UNITED STATES  
NUCLEAR REGULATORY COMMISSION  
WASHINGTON, D. C. 20555

RE: OCONEE NUCLEAR STATION, UNITS 1, 2 AND 3

SAFETY EVALUATION AND STATEMENT OF STAFF POSITIONS  
RELATIVE TO THE EMERGENCY POWER SYSTEMS  
FOR OPERATING REACTORS

### Response to NRC Staff Position on Degraded System Conditions

### MODIFICATION DESCRIPTION

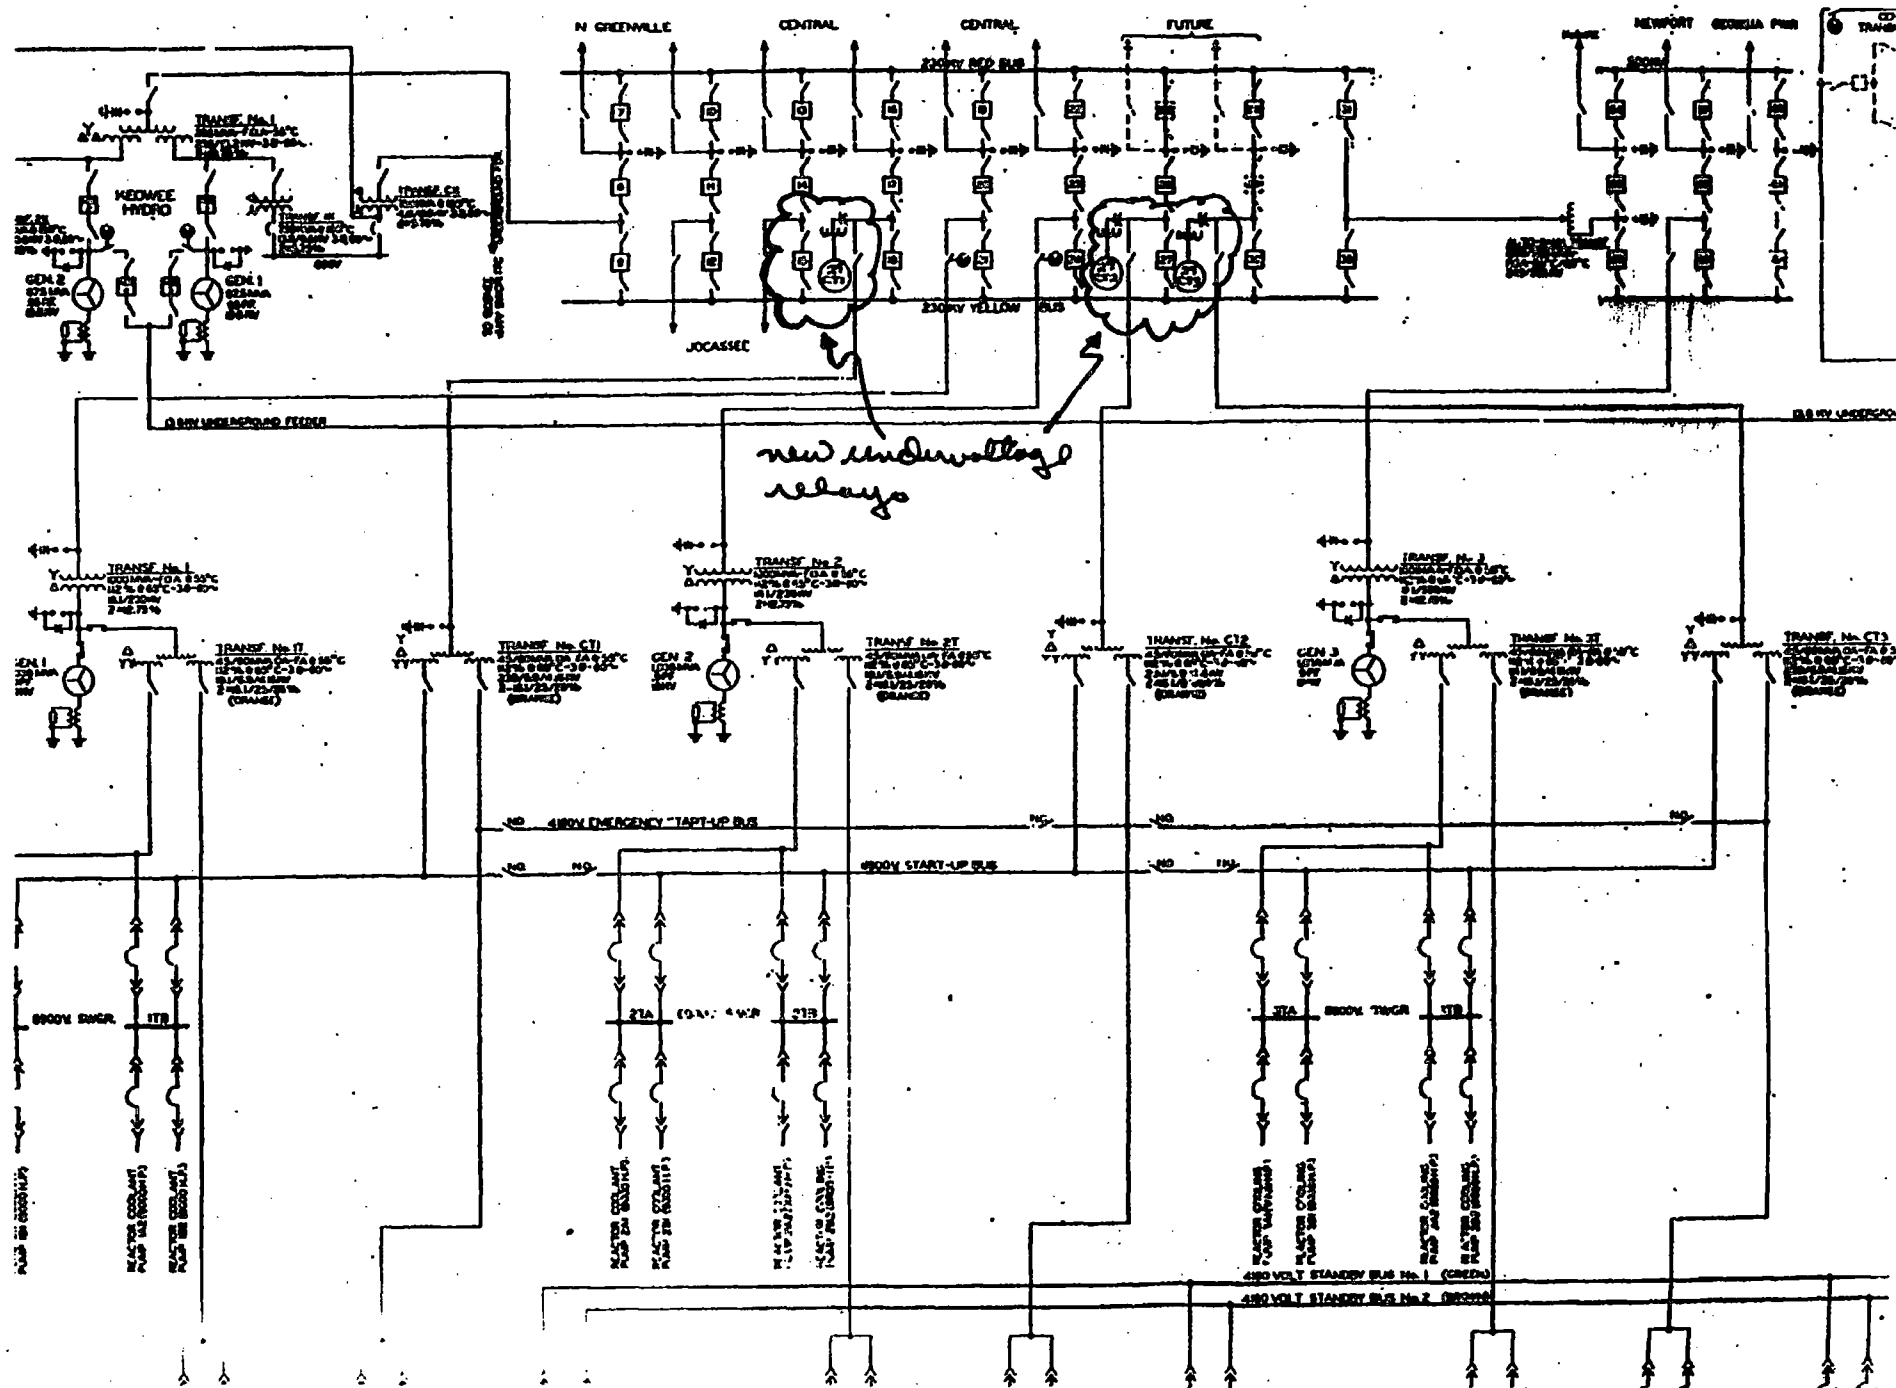
The modification will install equipment that will provide an annunciator alarm in the Unit 1 and 2 control room, an alarm via the unit Operator Aid Computer an alarm to the Power Systems Control Area Operation Center and an event recorder point and, if an ES signal occurs on any unit while the voltage is at or below the setpoint, will automatically isolate the switchyard by initiating the External Grid Trouble Protection (EGTPS) system. The new logic will ensure the overhead power path from Keowee is available during an ES event, even if the switchyard voltage is below 219KV. The modification will install several relays to accomplish this logic.

The EGTPS is designed to detect undervoltage or underfrequency conditions on both buses in the 230KV switchyard and to isolate the yellow bus, (and thus the Keowee overhead path), from the transmission system if these conditions occur. To address the difference between the minimum analyzed voltage for starting LOCA loads and the voltage at which the EGTPS is automatically initiated, the above modification was proposed.

Oconee Nuclear Station  
Preliminary Logic Diagram  
230KV Switchyard Degraded Voltage Protection  
NSM ON-52850  
May 4, 1990

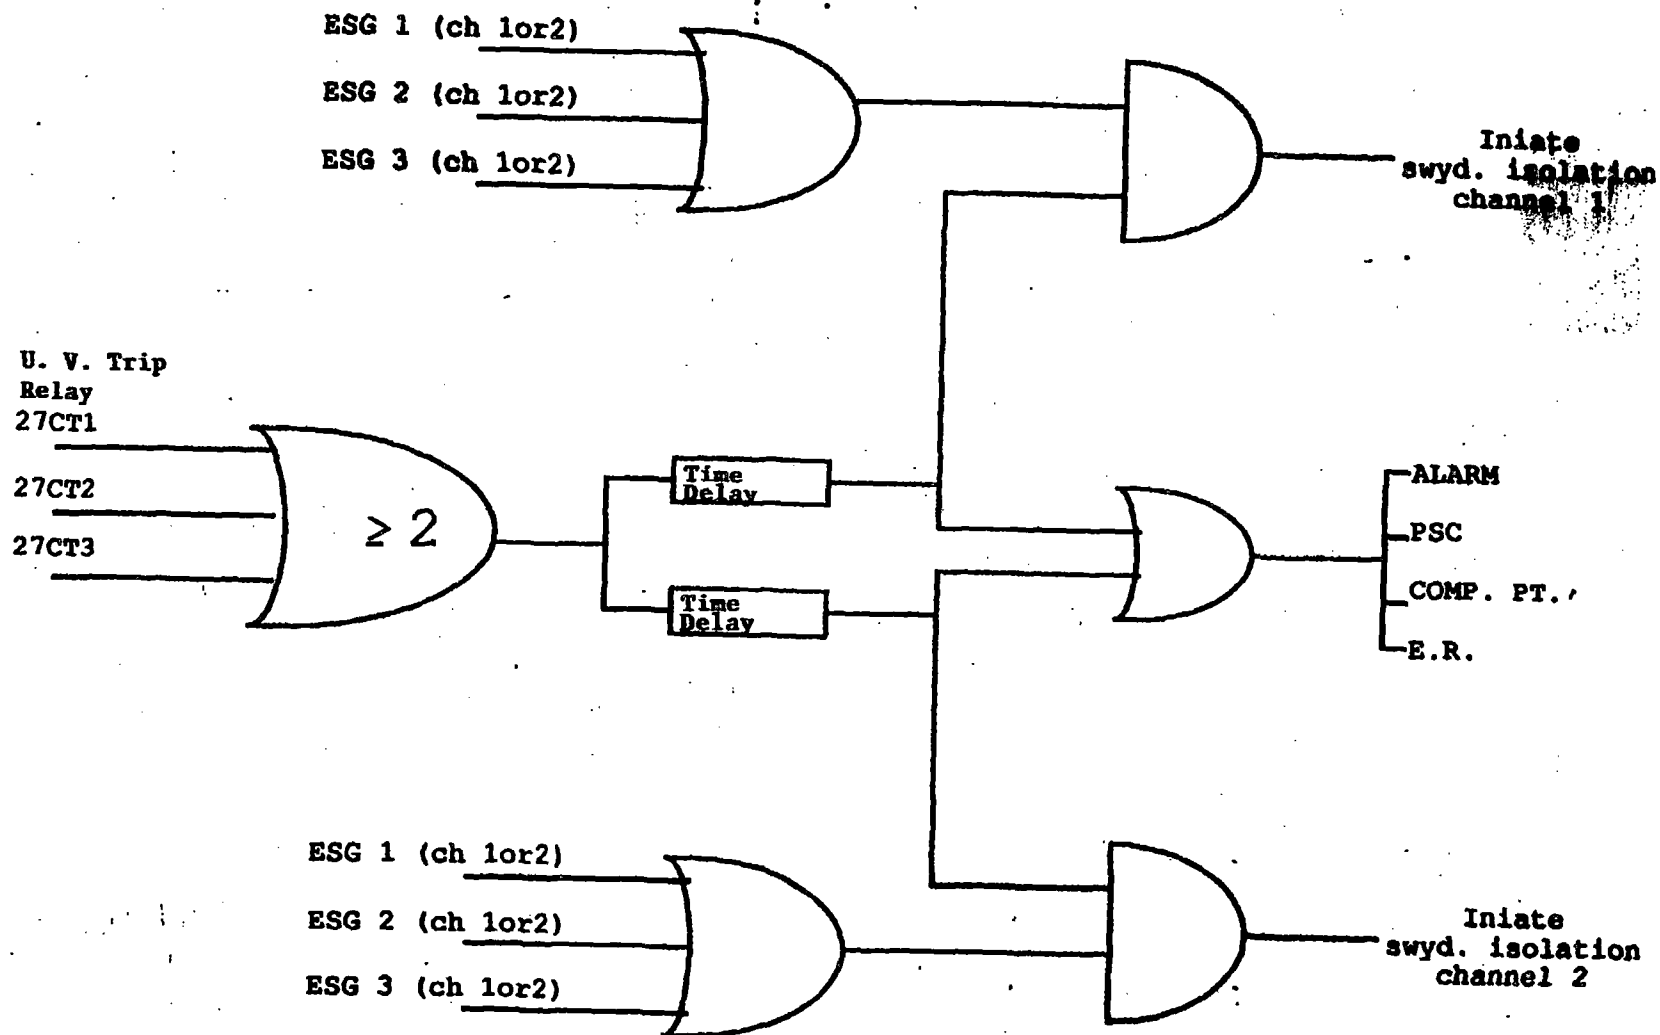
In a letter dated May 8, 1990, the licensee provided a description of the conceptual design for a degraded grid protection hardware modification intended as the permanent corrective action. We have reviewed the conceptual design and find it acceptable as discussed below.

In a letter dated May 8, 1990, the licensee provided a conceptual description of the permanent hardware modification intended to eliminate the design deficiencies. New undervoltage relays with setpoints of 222.5kV will be installed utilizing existing potential transformers in one phase on the primary side of each unit's startup transformer. Two-out-of-three logic will be used to generate an undervoltage signal. After a 9 second time delay this signal will then generate alarms in the control rooms and, if an ES signal from any unit's Engineered Safeguards Protective System exists, will then isolate the 230 kV switchyard from the offsite 230 kV electrical grid.

The design modification has only the 9 second fixed delay. A second, longer time delay has not been incorporated into the design. Also, the undervoltage condition in itself does not result in the separation of the Class 1E distribution system from the offsite grid; an ES (LOCA, MSLB) signal must exist coincidentally before undervoltage protective action occurs.

In response to a staff question, the licensee stated, in a phone conference call, that after a degraded grid alarm is received, steps will be taken to re-establish an adequate voltage level on the grid. For a sustained degraded grid condition, analyses (see licensee's letter dated June 18, 1990) related to LERs 269/90-04 and 269/90-05 have been performed covering equipment and plant performance down to the worst setpoint (203 kV) of the existing degraded grid protection circuitry. This circuitry will remain installed and will provide automatic separation from the grid for scenarios without an ES signal and where voltages drop to levels near where equipment/plant performance is unanalyzed.

In response to a staff question, the licensee stated in a phone call that all relays, timers, and auxiliary relays used in the new undervoltage scheme would be Class 1E. Although it is derived from a Class 1E source, the 125 vdc control power will be non-Class 1E utilizing components similar to Class 1E components. The non-Class 1E potential transformers (PTs) are also similar to Class 1E PTs and are seismically mounted.
